工程指示 / 要求簡箋(E.I.)

工程指示編號：EI / 9243 / 25 修改版次：

工程編號：J - 858 工程名稱：將軍澳日出康城

工程項目：幕牆 第 15 次 補玻璃 19 件 (小業主單)

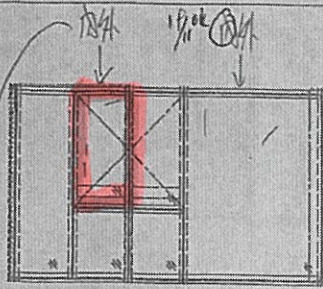
換大邊磨到  
6602-05

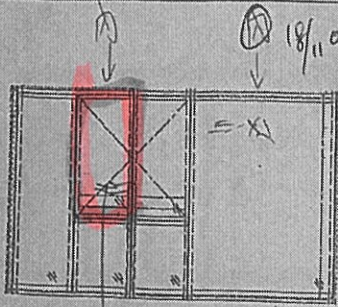
高金窗右邊磨唔到  
6/02/05

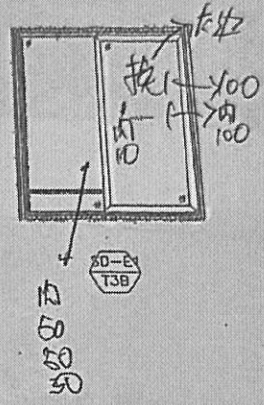
22-7-2005 實地已磨水

鋁門外框色執膠

幕牆執收蓋

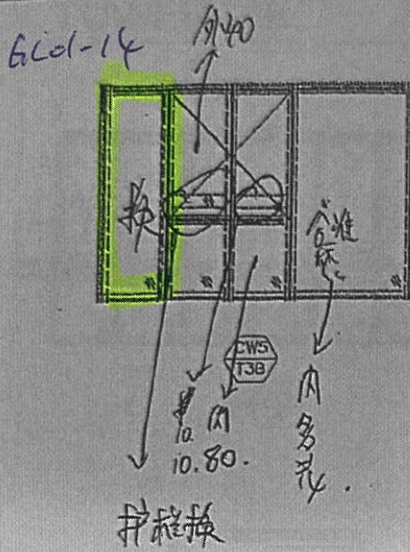
OK 已磨 22-7-2025 室內

執色幕牆, 膠差, 補膠,

鋁門執色漏風,

執色門外.

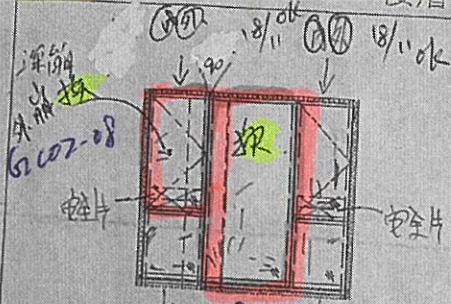
主大梗化料線  
及窗框料換  
Kullu

1 PART ELEVATION FOR CURTAIN WALL

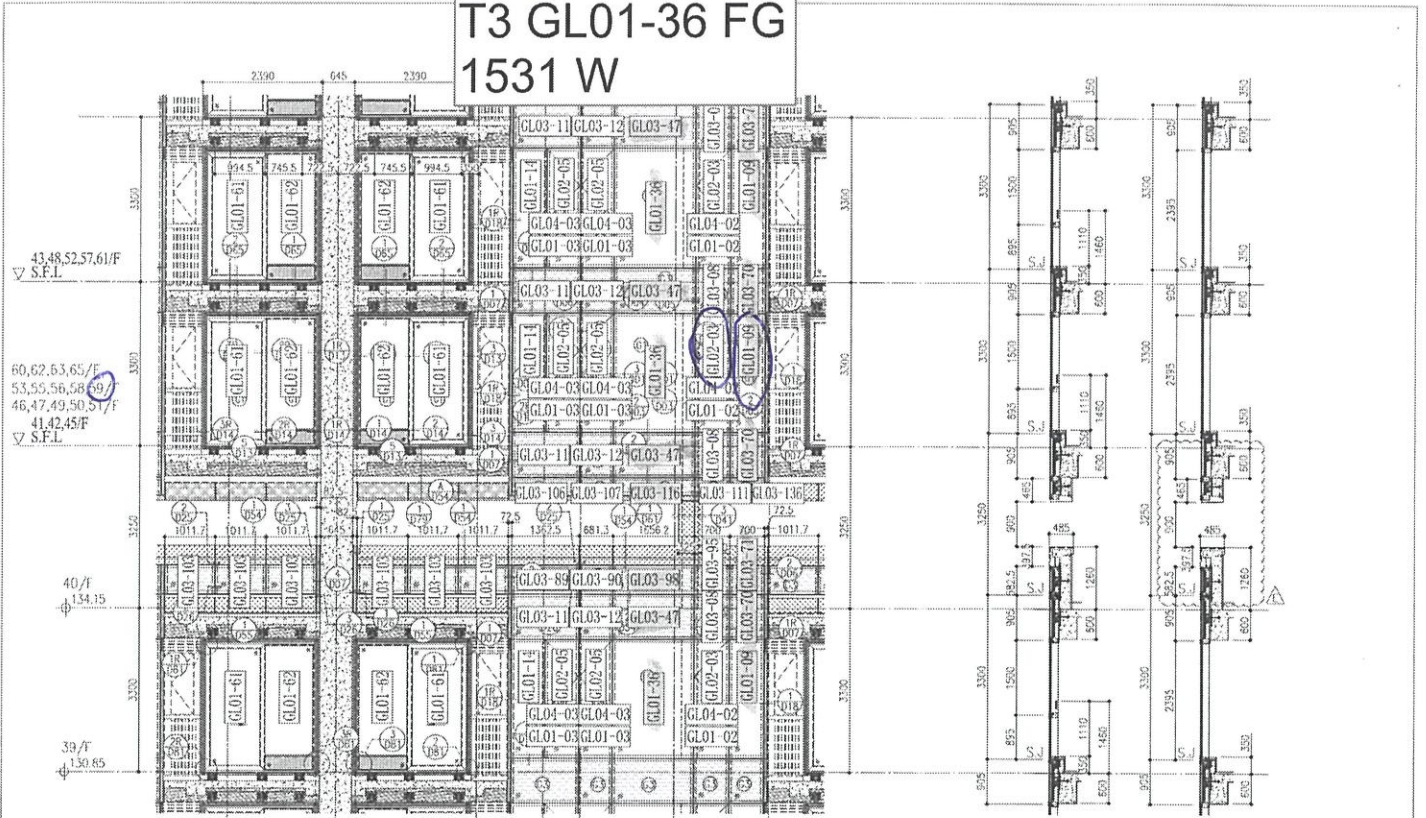
*Handwritten notes:*  
 GL01-09  
 59AG  
 50A9  
 F G  
 GL02-03  
 59AG

1 PART ELEVATION FOR CURTAIN WALL

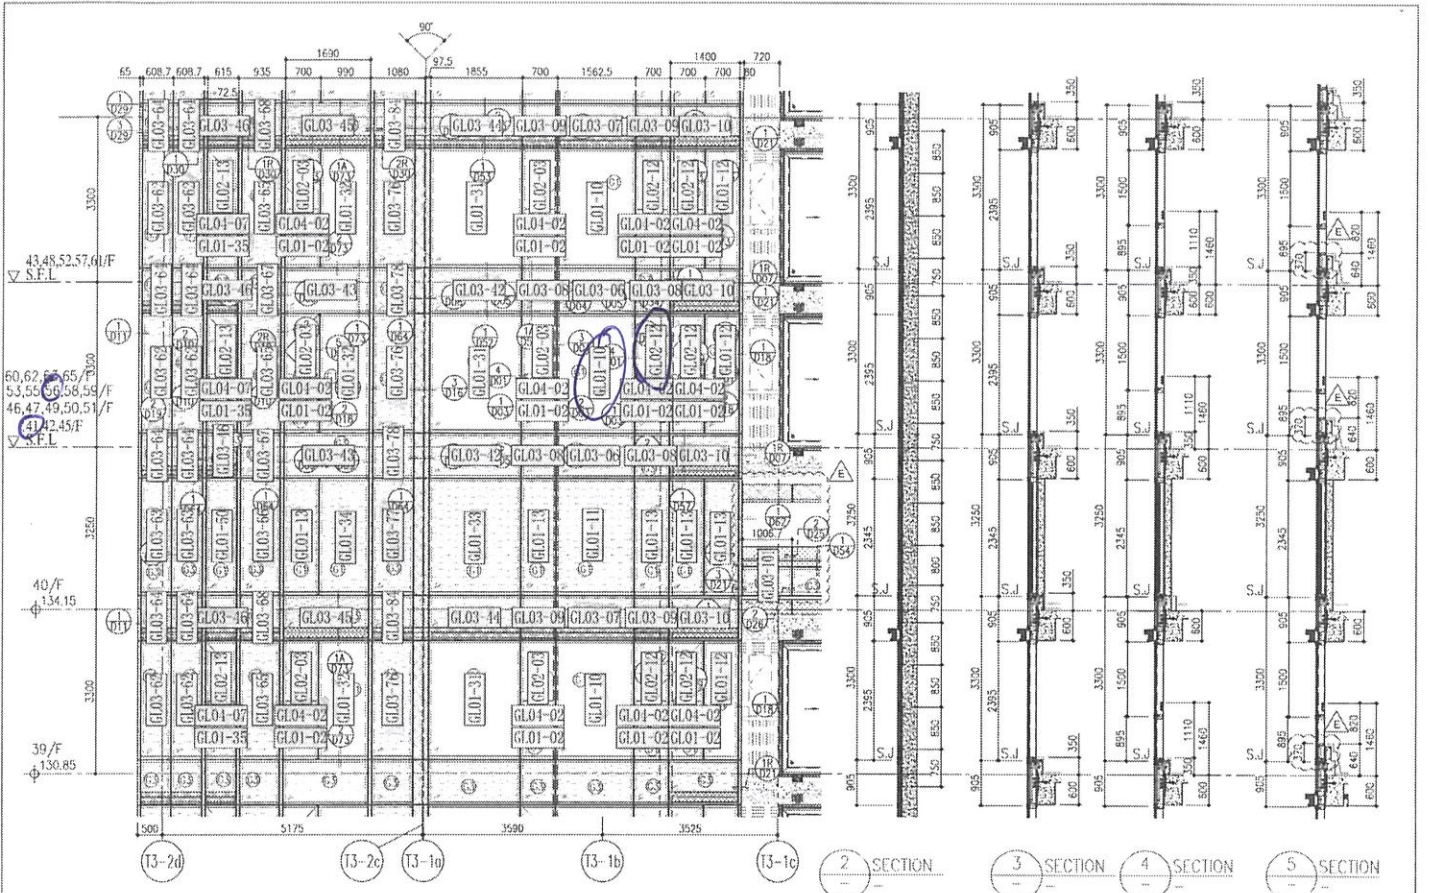
GL01-10  
5EAB

GL02-12  
6EAB

1 PART ELEVATION FOR CURTAIN WALL

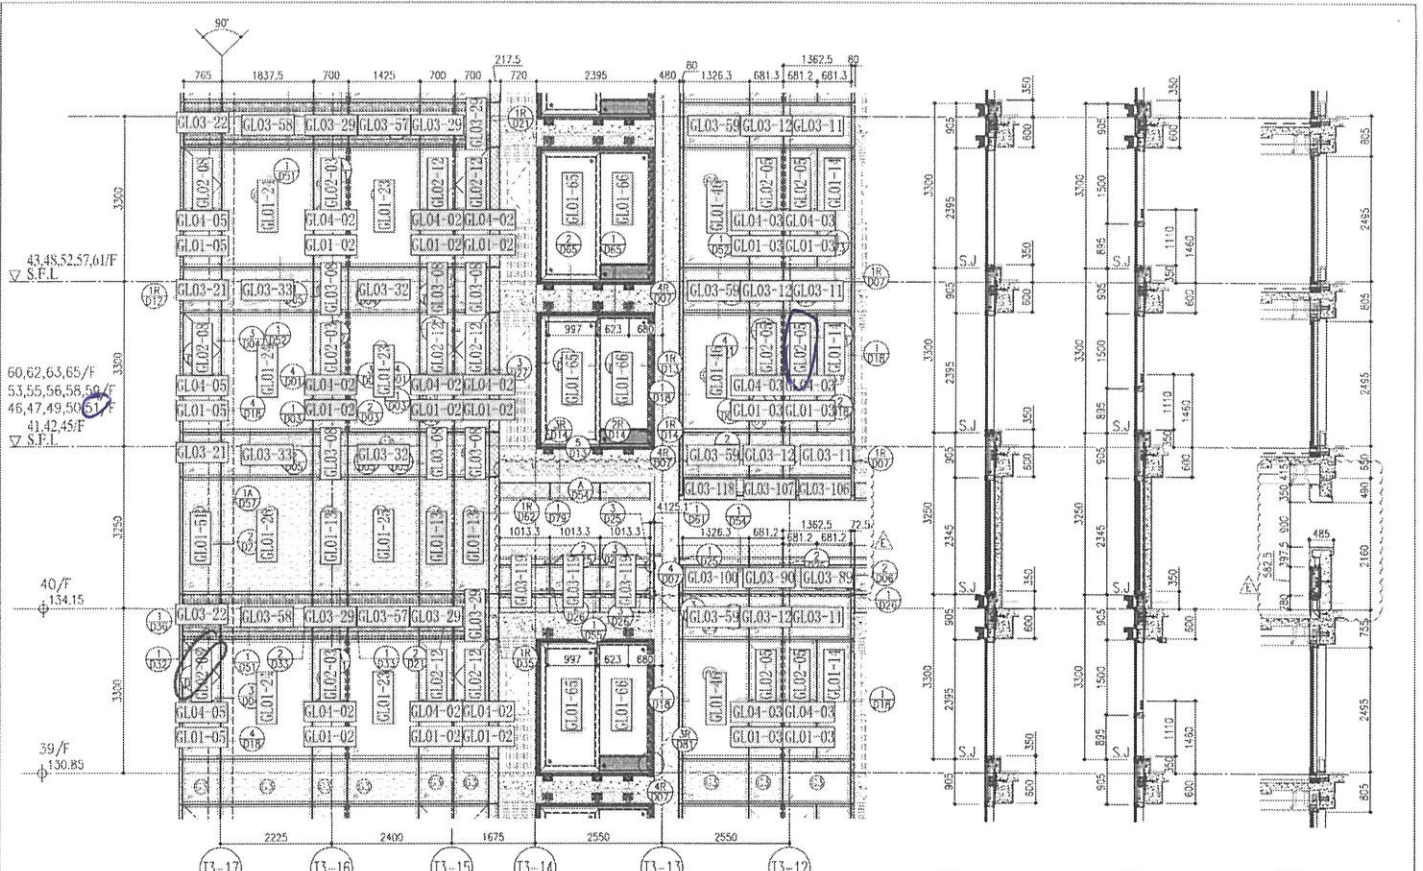
GLO2-01  
SIBE

13 PART ELEVATION FOR CURTAIN WALL

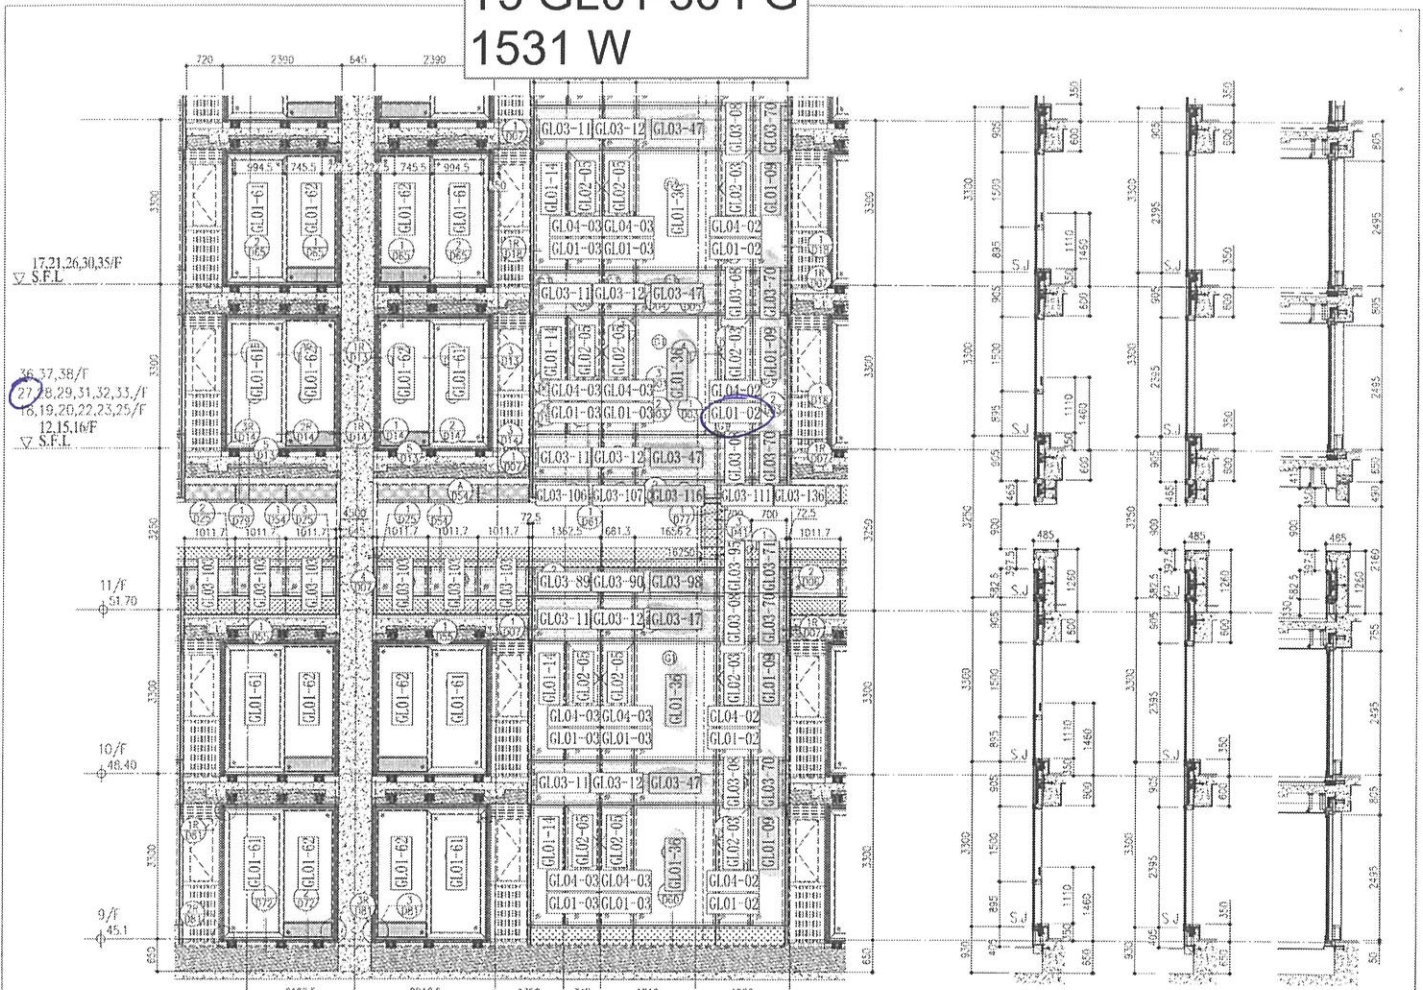
GC01-02  
27 AG

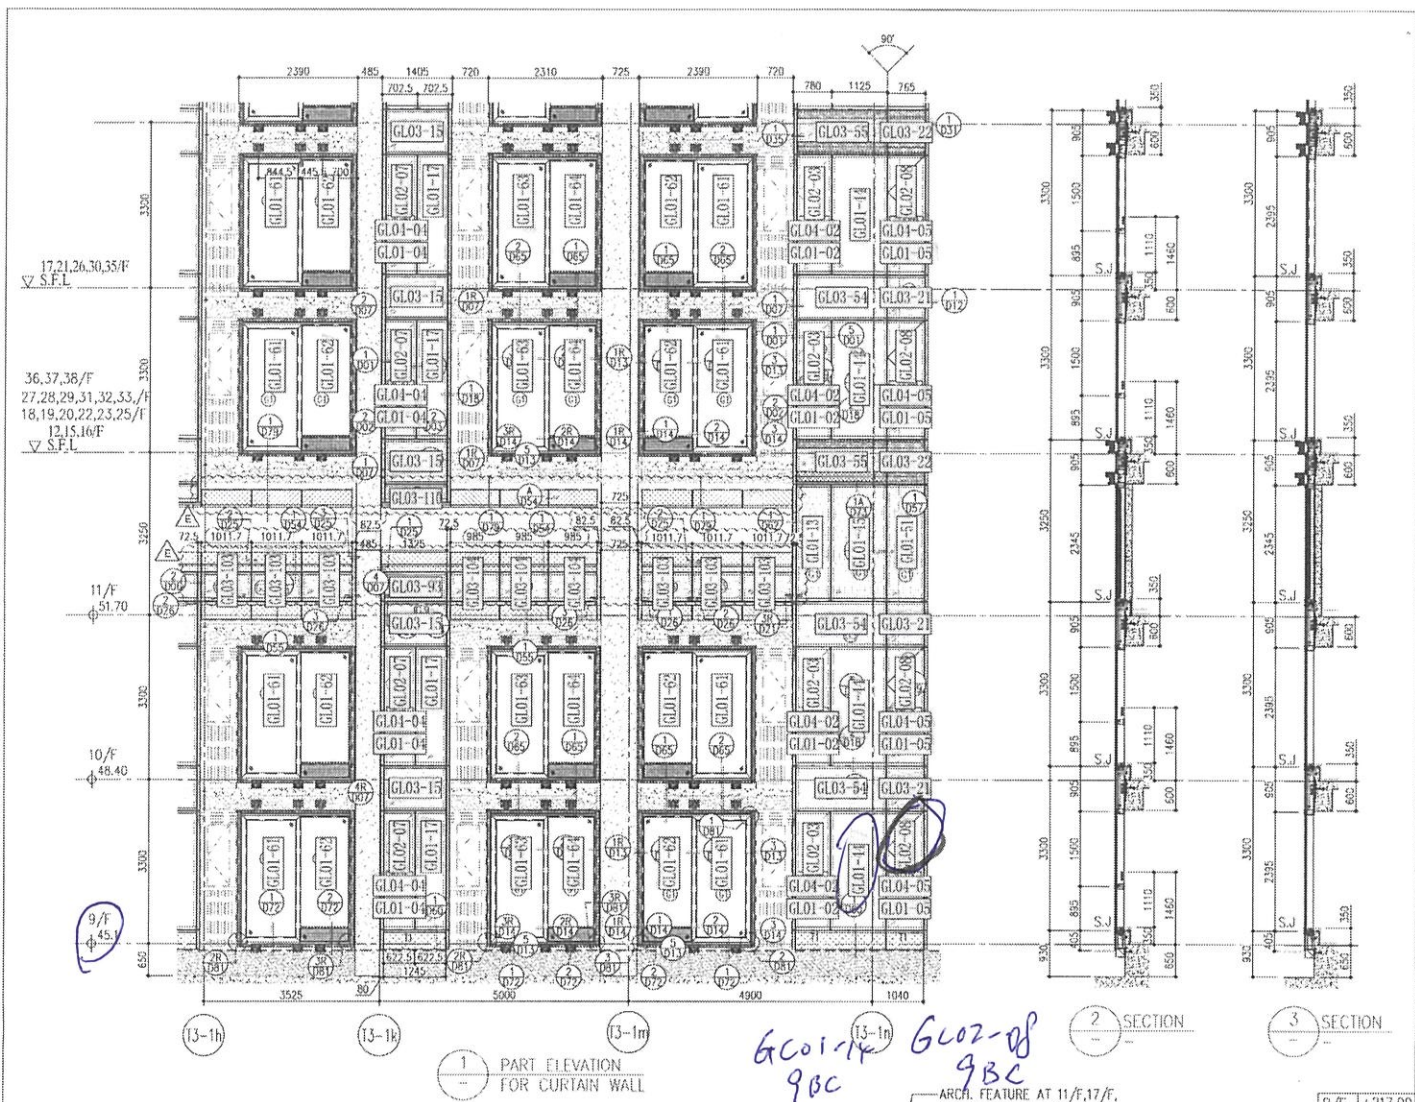
6001-14 9BC  
6002-08 9BC
